SUBJECT: SAFETY RECALL OF 2010 J MODEL COACHES WITH BRAUN WHEELCHAIR LIFTS

Ref.: **NHTSA # 11V-144**
TRANSPORT CANADA #TC 2011-091
MCI Service Bulletin 347

Service Bulletin No. 347

| SUBJECT BRAUN HYDRAULIC AND ELECTRICAL LINE INTERFERENCE | | | |

Figure 1.

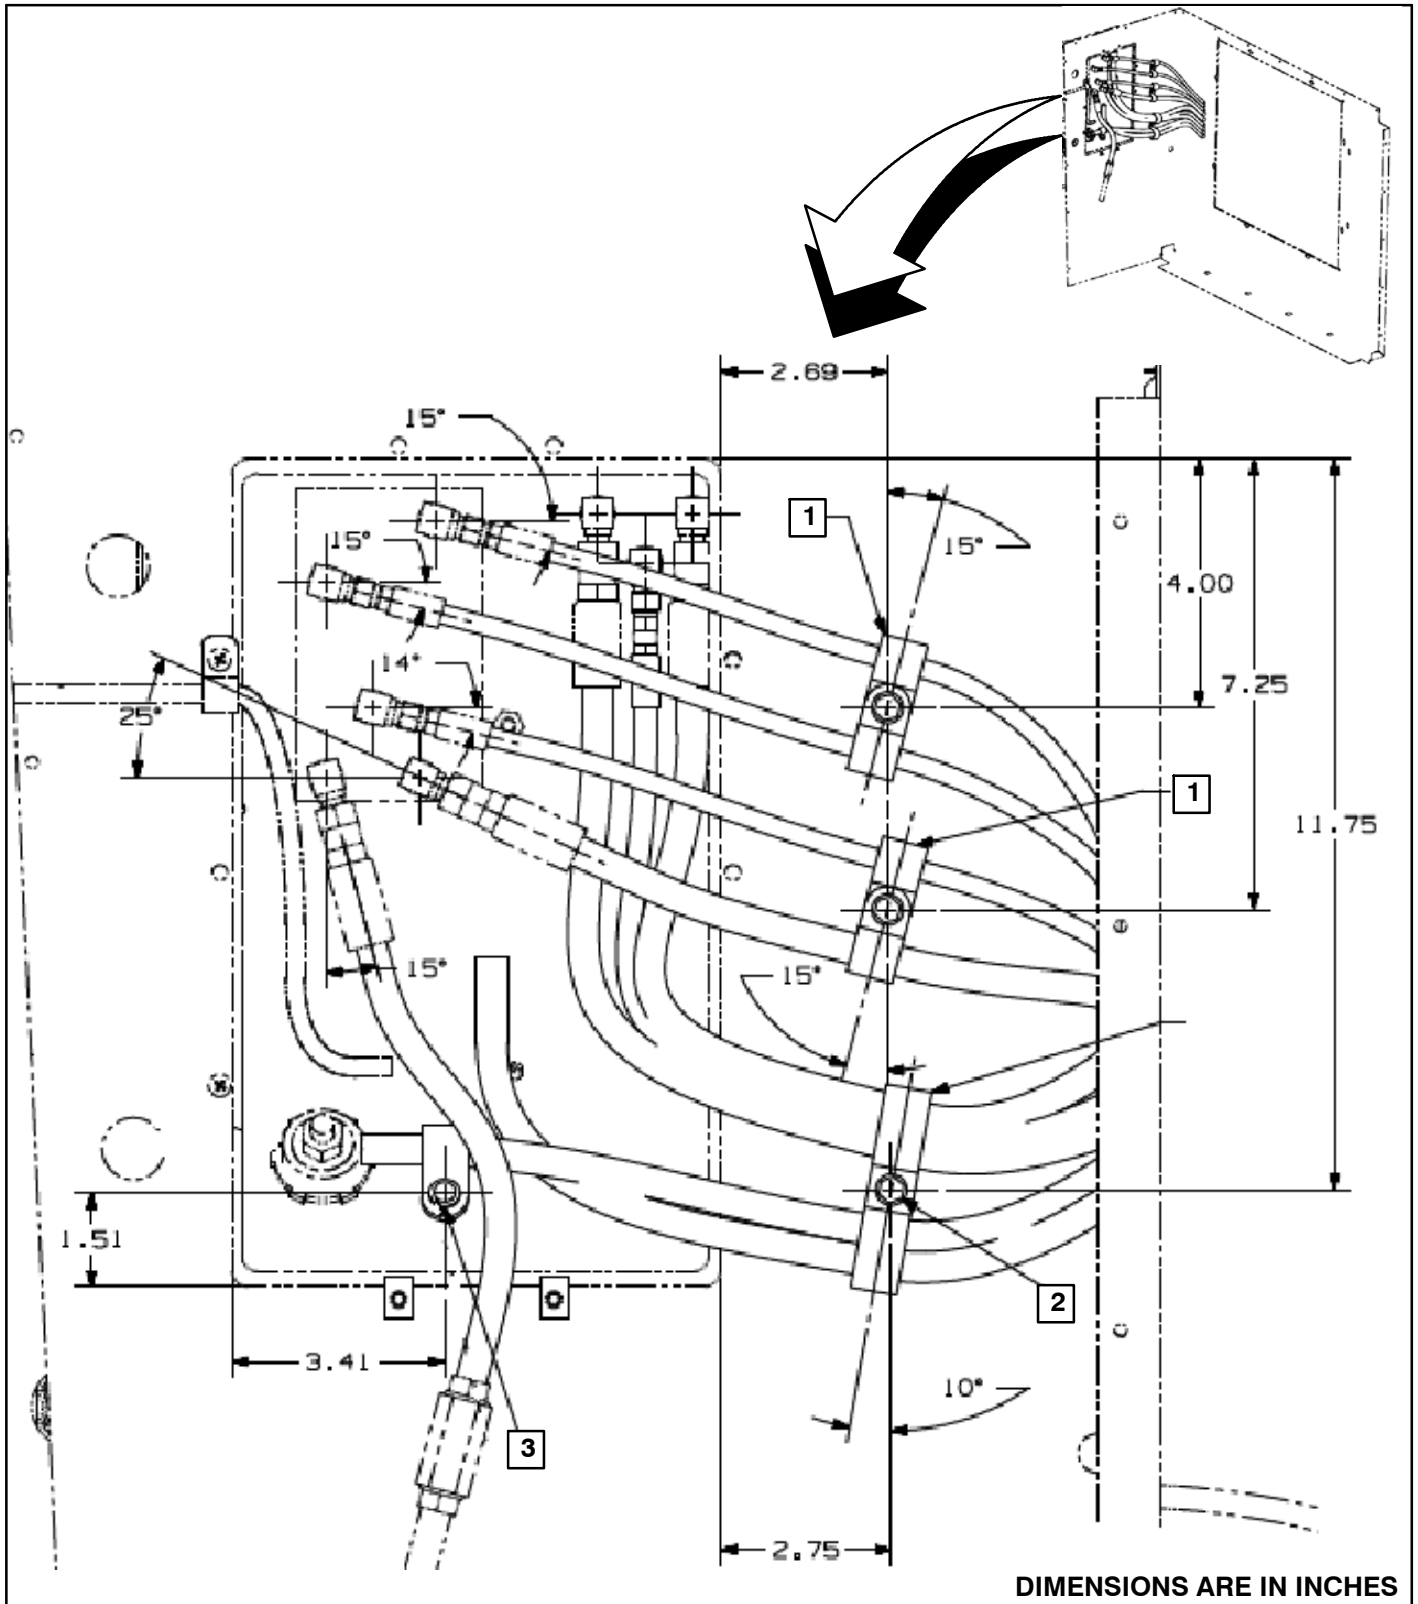
4. Open the curbside, rear side service compartment door.
5. Locate the fittings shown in Figure 1. Orient the harnesses and cables as shown in Figure 1.

7. Using a 13/64 inch drill bit and a drill bit stop (set to the width of the compartment wall), drill three (3) holes at the dimensions shown in Figure 1.

| ITEM | FIGURE 1 DESCRIPTION |
|------|---|
| 3 | Re-locate existing clamp (refer to Step 9.) |

Figure 2. Reference photo of wheelchair compartment.

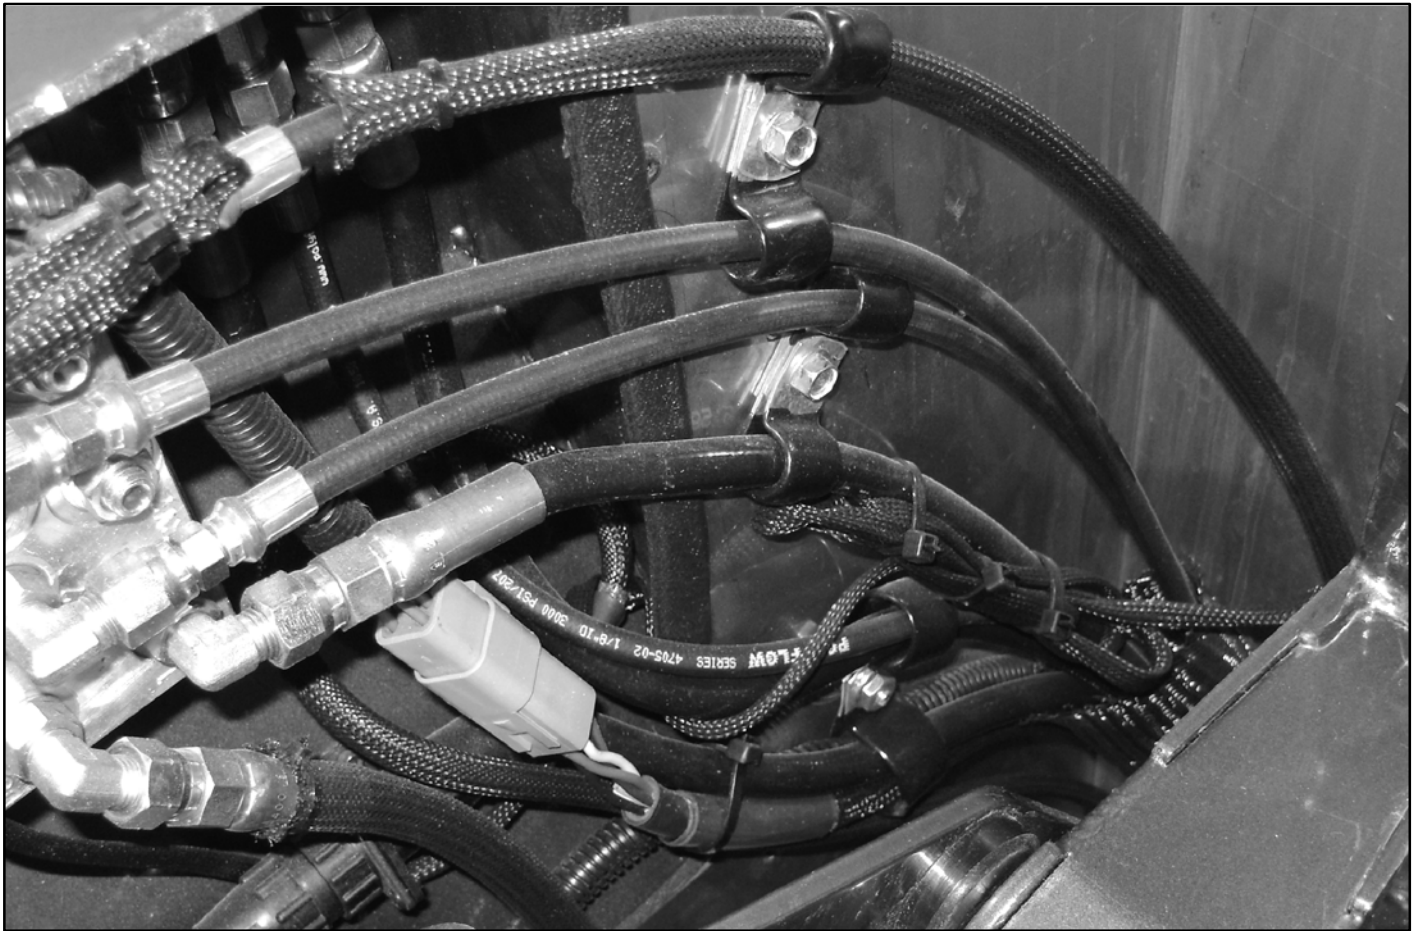
8. Install the clamps, p/n 19-4-32, and, p/n 19-4-48, on the hoses as shown in Figures 1 and 2. Using screws, p/n 19-4-176, and nut, p/n 19-3-2, secure the clamps to the compartment wall.

Figure 4. Reference photo of mounting hardware on rear, side service compartment side wall.

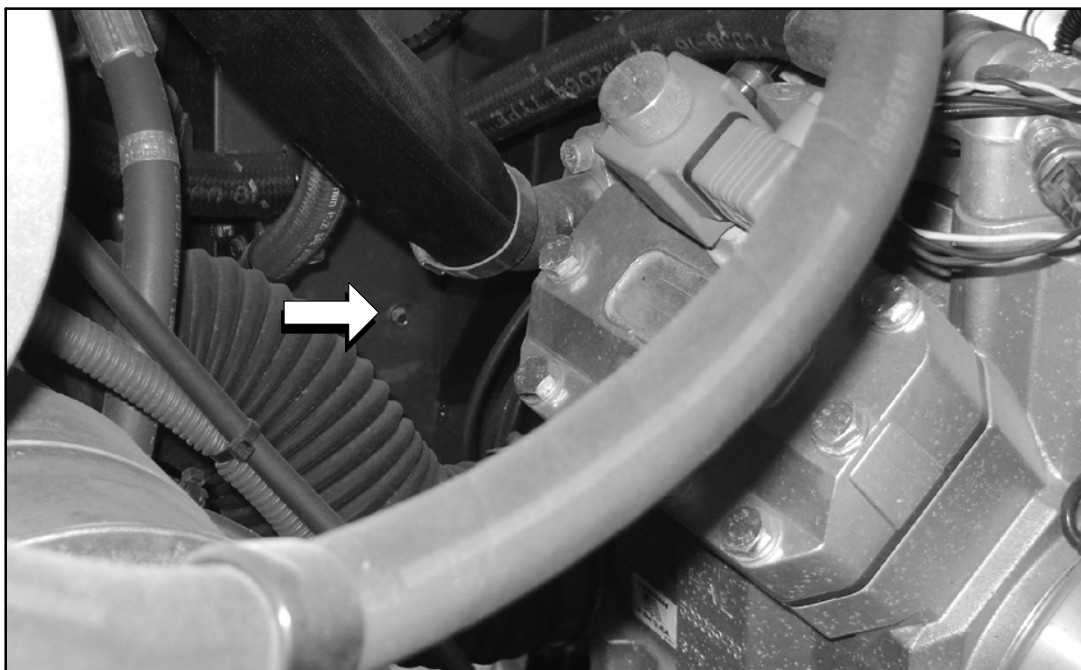
Utilize the rear, side service compartment to access the screw threads (refer to Figure 4).

Figure 5. Reference photo of wheelchair compartment.

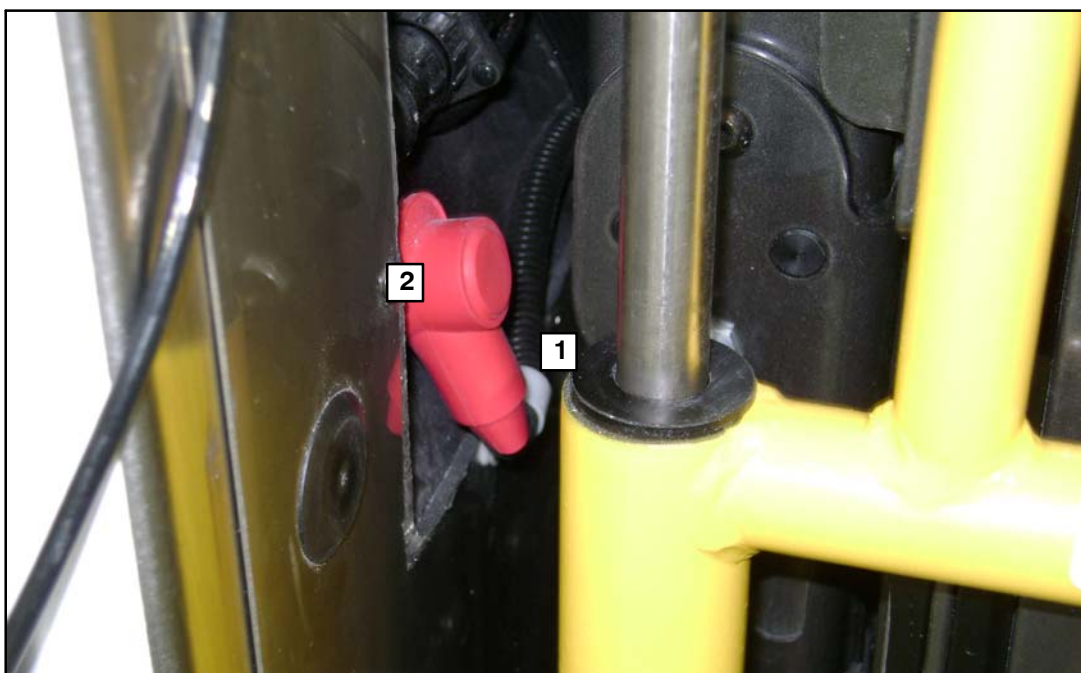
- 9. Using a 11/64 inch drill bit and a drill bit stop (set to the width of the compartment wall), drill a hole at the dimensions (1.51 x 3.41) shown in Figures 1 and 5. Secure the existing clamp to the compartment wall using screw, p/n 19-1-619, and washer, p/n 19-2-7.

10. In the wheelchair compartment, remove the red protective boot from the one (1) wheelchair lift electrical terminal and apply high tack sealant to the terminal (refer to Figure 5).
11. In the rear, side service compartment, remove the red protective boot from the three (3) wheelchair lift electrical terminals and apply high tack sealant to the terminals (refer to Figure 6).
12. Install the edge molding, p/n 24-51-0050, on the upper bracket edge (below the loom routing) as shown in Figure 6.

Figure 6. Reference photo of rear, side service compartment

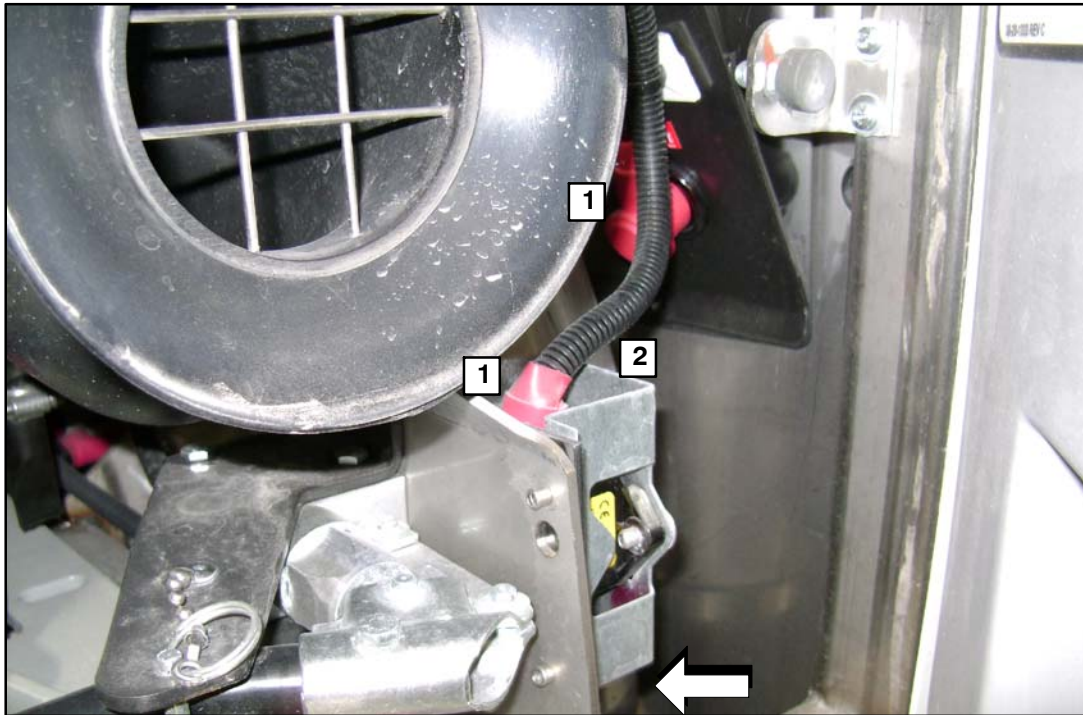
| ITEM | FIGURE 6 DESCRIPTION |
|-------------|--|
| 1 | Remove the red protective boot and apply high tack sealant to the terminals |
| 2 | Install the edge molding |
